**Re: Canadian Niagara Power Inc. (Canadian Niagara Power)  
2027 Cost of Service Rate Application  
Ontario Energy Board (OEB) File Number: EB-2026-0029**

**OEB Staff Interrogatories**  
**2027 Electricity Distribution Rates Application**  
**Canadian Niagara Power Inc. (Canadian Niagara Power)**  
**EB-2026-0029**  
**August 5, 2026**

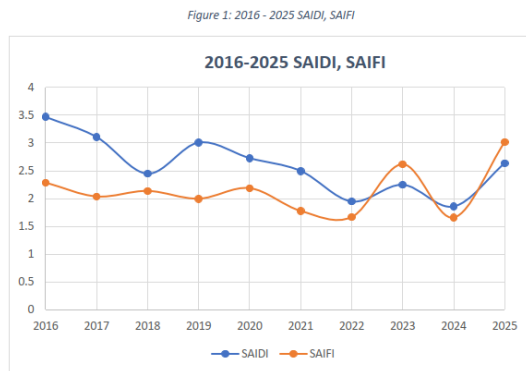
CNPI states that its proposed modernization investments are expected to reduce SAIDI and SAIFI and support its 2027 reliability targets (~2.28 and ~ 2.00). Historical performance, excluding the 2023 and 2025 outliers, has trended downwards and even exceeded those targets in 2022 and 2024.

**Question(s):**
